LAND USE APPLICATION SUMMARY

Property Location: 815 13th Avenue SE
Project Name: 815 13th Avenue SE – Building Expansion
Prepared By: Becca Farrar-Hughes, Senior City Planner, (612) 673-3594
Applicant: 815 13th Ave SE, LLC, Attn: Daniel Oberpriller
Project Contact: Harriss Associates, LLC, Attn: John Harriss
Request: To expand an existing multiple-family residential structure.
Required Applications:

Variance	Of the interior side yard setback requirement along the north property line for building additions from 7 feet to approximately 1.8 feet;
Variance	Of the interior side yard setback requirement along the south property line adjacent to the public alley for building additions from 7 feet to 0 feet;
Variance	Of the off-street parking requirement from 47 to 40 spaces;
Site Plan Review	To allow additions to the existing multiple-family residential structure.

1 PROPOSED LANDSCAPE PLAN
A1-1 SCALE: 1/16" = 1'-0"
3424-PLN-SITE

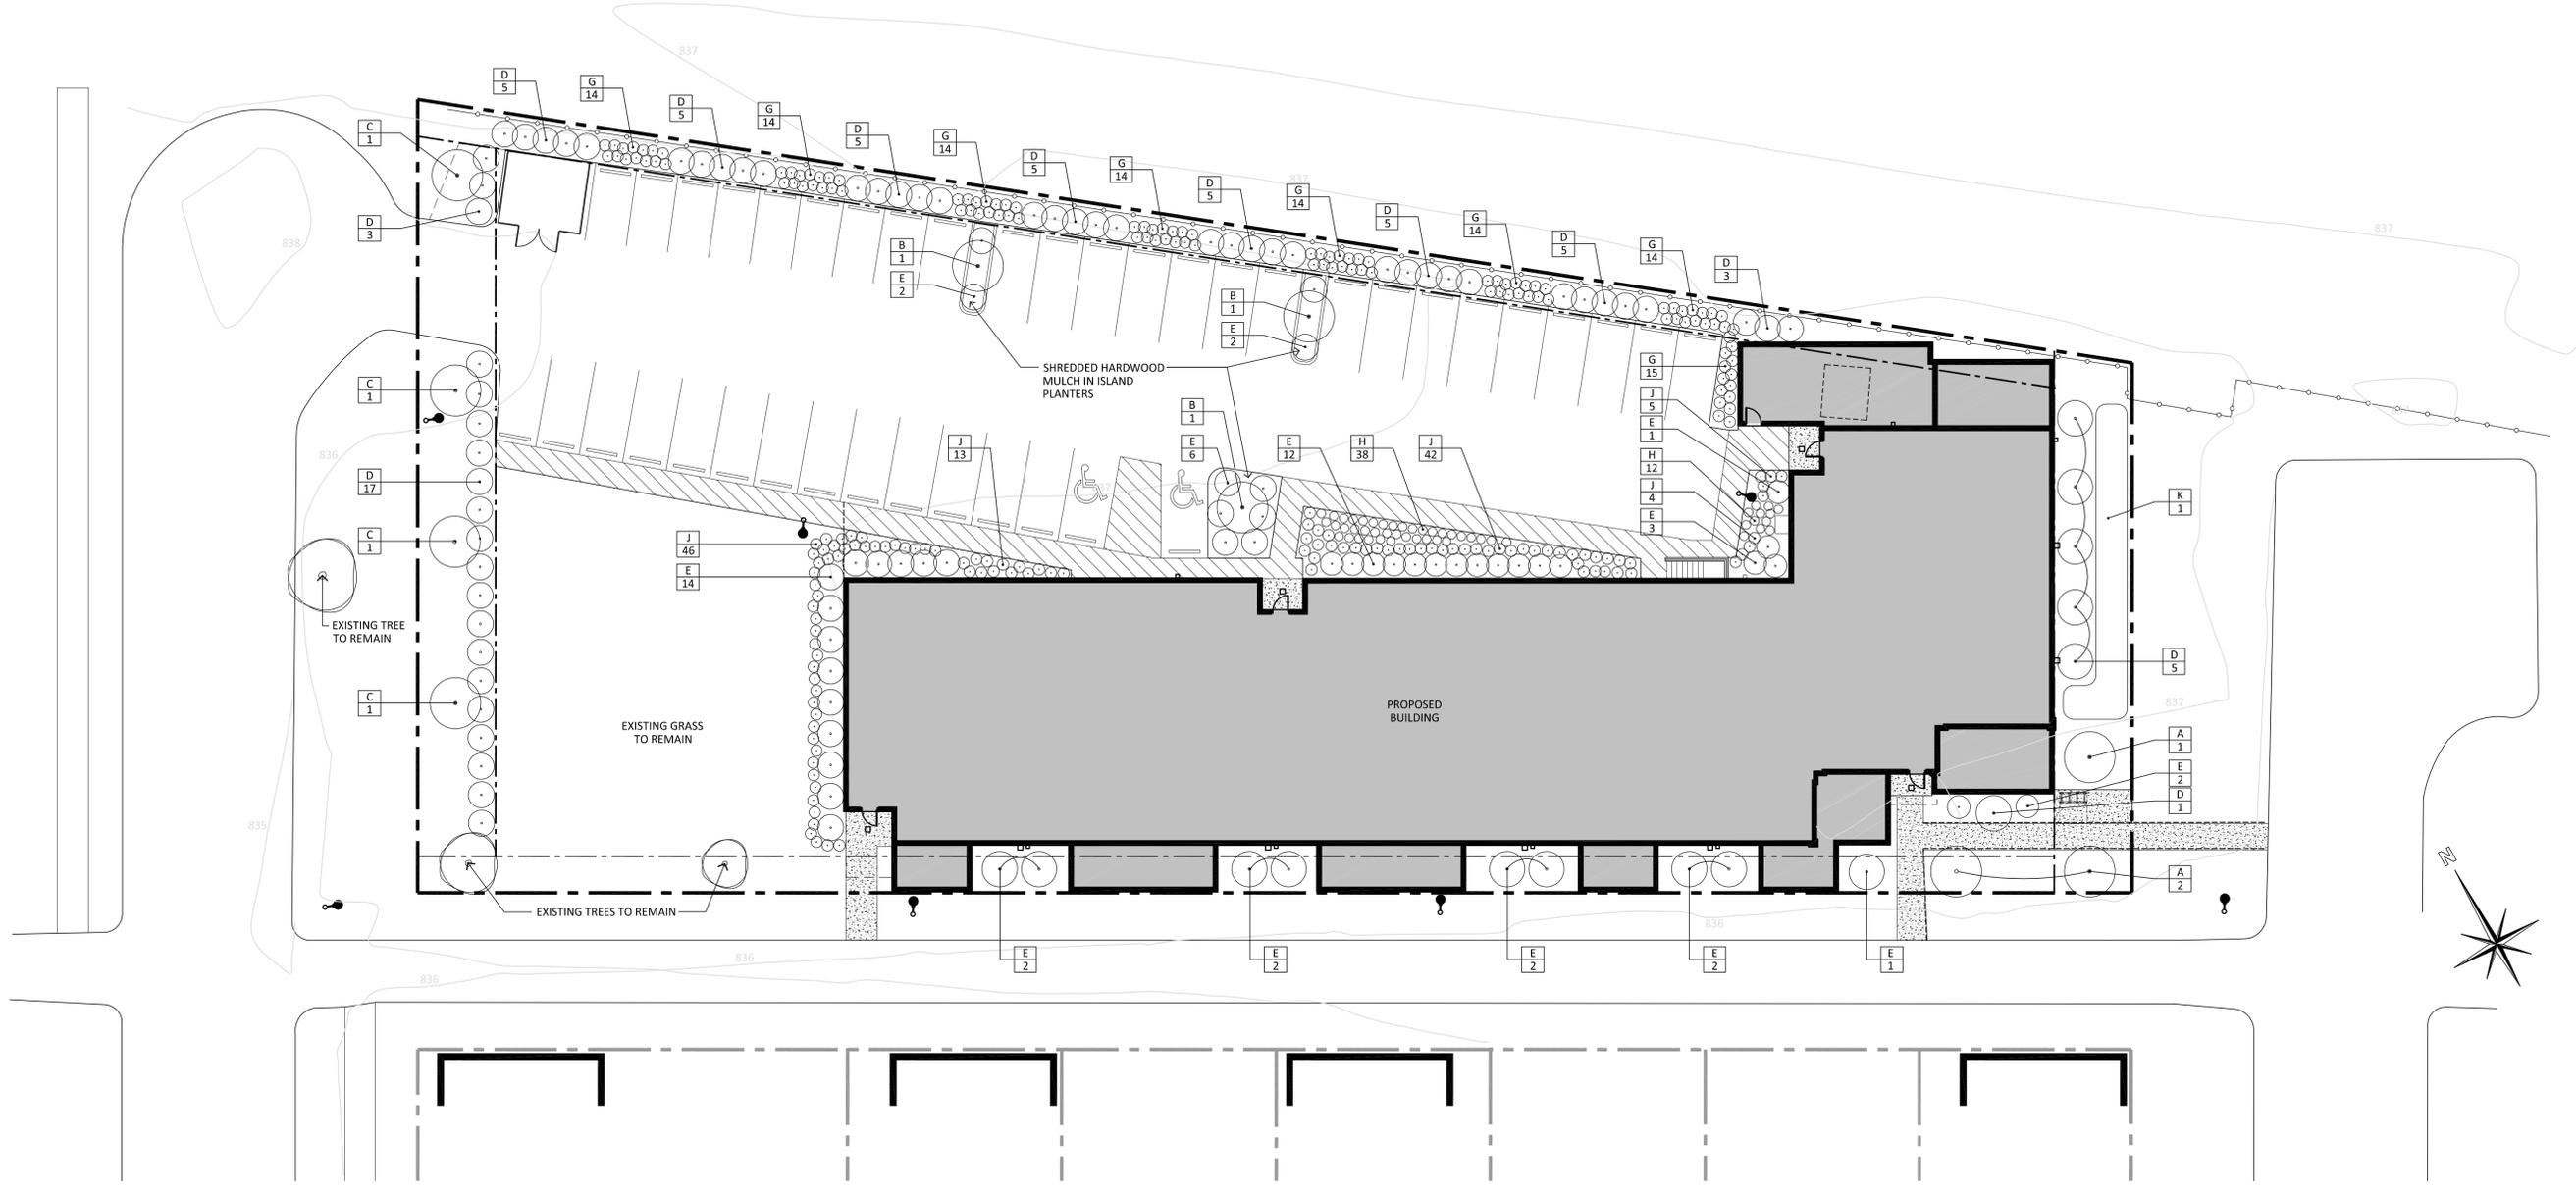
- The composition and location of landscaped areas complement the scale of the development and its surroundings.
- There is a large existing surface parking lot located on site. While it will be reduced in size and resurfaced, it will still occupy a significant portion of the site. The parking lot is subject to a 7-foot wide landscaped yard along 12th Avenue SE as well as a screening requirement that is 3 feet in height and a minimum of 60% opaque. In addition, not less than one tree for each 25 linear feet of parking lot frontage is required along the public street. The applicant is proposing a 15 foot landscaped yard that includes a continuous hedge that meets the screening requirement as well as a tree for each 25 linear feet of parking lot frontage.

- The parking lot is also subject to a 7-foot landscaped yard and a screening requirement that is a minimum of 95% opaque adjacent to the north property line as it is residentially zoned, and along a portion of the south property line where the parking lot is exposed to the residential uses/zoning located across the alley. The applicant is proposing a 7-foot landscaped yard along the north property line abutting the surface parking lot that incorporates a continuous hedge that meets the screening requirement. The parking lot facing the south lot line is approximately 75 feet to 86 feet

from the property line. While it is not directly abutting the property line, the area is all sod and no vegetation is provided to screen the parking. Alternative compliance would be necessary. Staff would recommend that the Planning Commission require that the applicant install a continuous hedge adjacent to the south property line where the parking is visible. The applicant proposes to utilize the areas directly adjacent to the parking in that location for snow storage.

- The Zoning Code requires that at least 11 canopy trees and 54 shrubs be provided on site. The applicant is proposing to install a total of 7 canopy trees, as well as 3 ornamental trees, 246 shrubs and 144 perennials. Alternative compliance would be necessary for the number of on-site canopy trees. Staff would recommend that the Planning Commission require compliance with this provision as there are on-site opportunities for additional canopy trees on the west side of the building.

- All areas and corner within the parking lot are landscaped.
- All parking spaces are not within 50 feet of an on-site deciduous tree. Alternative compliance is necessary. Staff would recommend that the Planning Commission grant partial alternative compliance. There are a total of 9 spaces within the parking lot that do not meet the spacing requirement; 3 of these spaces are located at the northwest end of the parking lot and the other 6 spaces are centrally located in the spaces located on the south side of the parking lot. It would not be practical to require compliance on the northwest side of the site, however, it would be practical to require compliance for the spaces centrally located on the south side of the parking lot.

- A total of 2 tree islands are proposed; both do not meet the requirement that they be at least 7 feet in any direction. Alternative compliance is necessary. Staff would recommend that the Planning Commission grant alternative compliance in this circumstance as the landscape islands are approximately 5 feet in width and 18 feet in length. Additional width would require the elimination of an additional parking stall.

the number of on-site canopy trees. Staff would recommend that the Planning Commission require compliance with this provision as there are on-site opportunities for additional canopy trees on the west side of the building.

- **Proximity of parking to deciduous tree.** All parking spaces are not within 50 feet of an on-site deciduous tree. Alternative compliance is necessary. Staff would recommend that the Planning Commission grant partial alternative compliance. There are a total of 9 spaces within the parking lot that do not meet the spacing requirement; 3 of these spaces are located at the northwest end of the parking lot and the other 6 spaces are centrally located in the spaces located on the south side of the parking lot. It would not be practical to require compliance on the northwest side of the site; however, it would be practical to require compliance for the spaces centrally located on the south side of the parking lot.

- **Width of tree islands.** A total of 2 tree islands are proposed; both do not meet the requirement that they be at least 7 feet in any direction. Alternative compliance is necessary. Staff would recommend that the Planning Commission grant alternative compliance in this circumstance as the landscape islands are approximately 5 feet in width and 18 feet in length. Additional width would require the elimination of an additional parking stall.
